# Skymountain 17505

CALUP

22-111870-EA

# Cover Sheet and Site Plan B

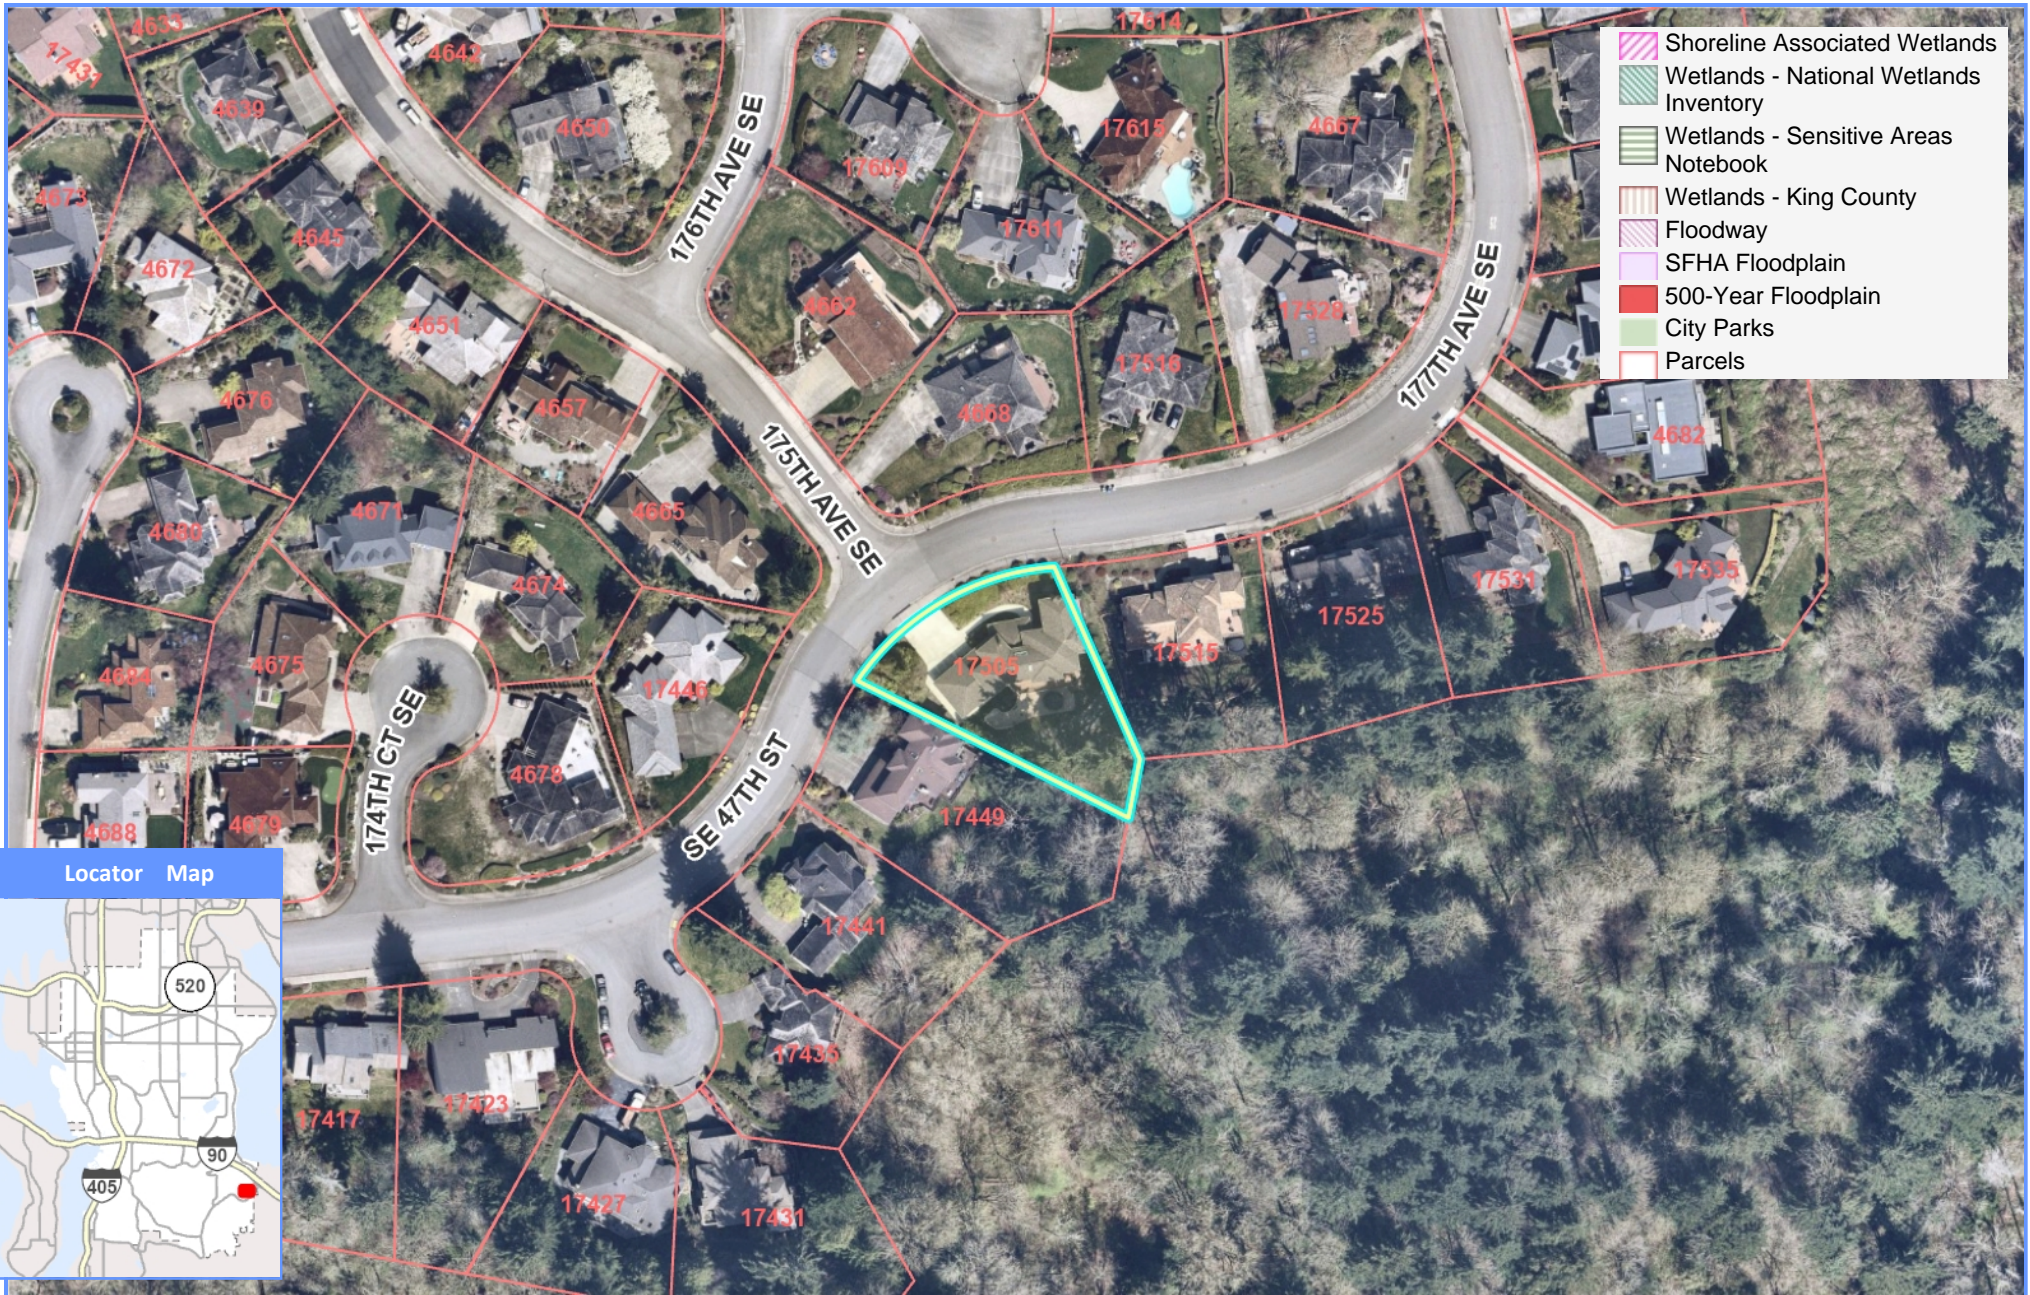
Utilities Comments: Show the pipes, structures and easement areas including recording number on this plan. Show for both storm and sewer pipes and easements.
